PRODUCT UPDATE

ULTRAA-K® Slider Box

LIT NO: P36027

DATE: May 2018

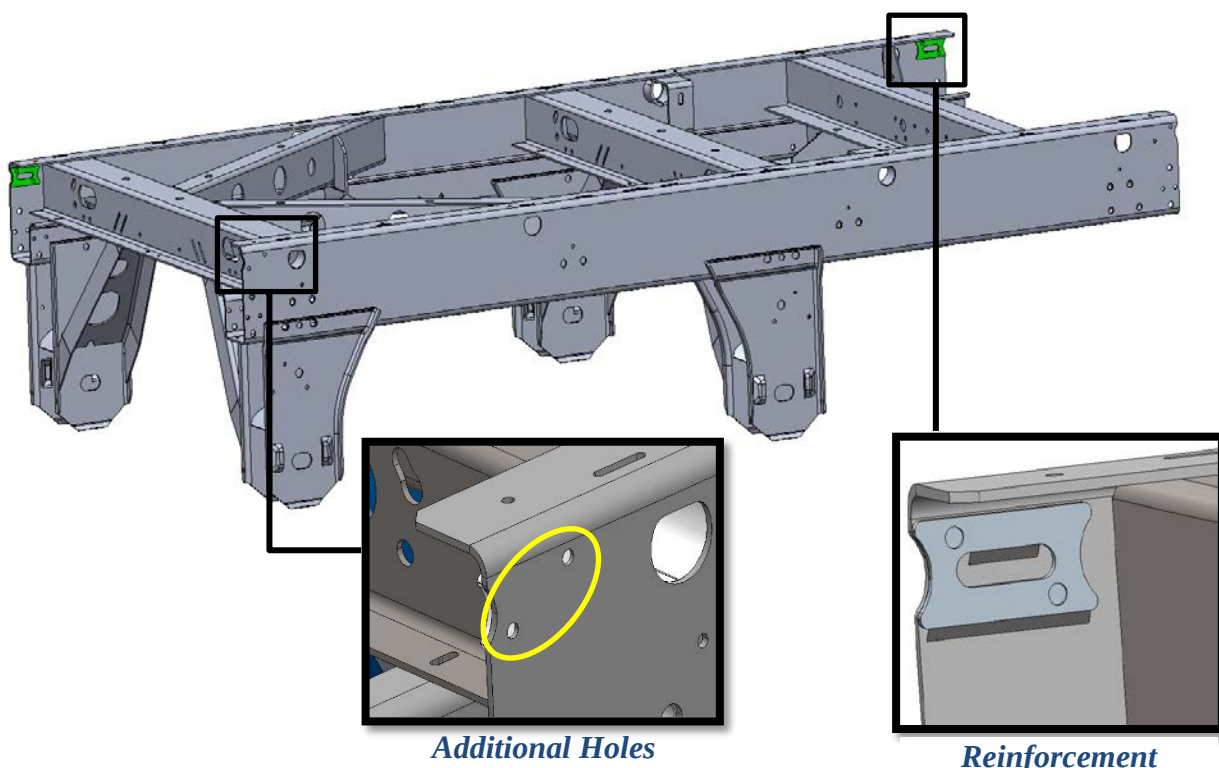
Beginning in May 2018, new production and aftermarket shipments of ULTRAA-K® slider boxes will feature additional holes on the rail at all four corners of the slider box. This change has no effect on product performance. ULTRAA-K and AMBOX model numbers will remain unchanged.

Hendrickson Trailer Commercial Vehicle Systems is excited to announce a further refinement to the ULTRAA-K® slider suspension system. Beginning in June 2018, ULTRAA-K sliders will feature a new reinforcement plate to enhance performance under aggressive sliding conditions. Located at the inboard end of the slider main rails, these reinforcement plates will not affect ULTRAA-K or AMBOX part numbers. Hendrickson is committed to providing world class products and service, this change is another incremental step in providing customers the very best slider suspension system.

Additional Holes

Reinforcement
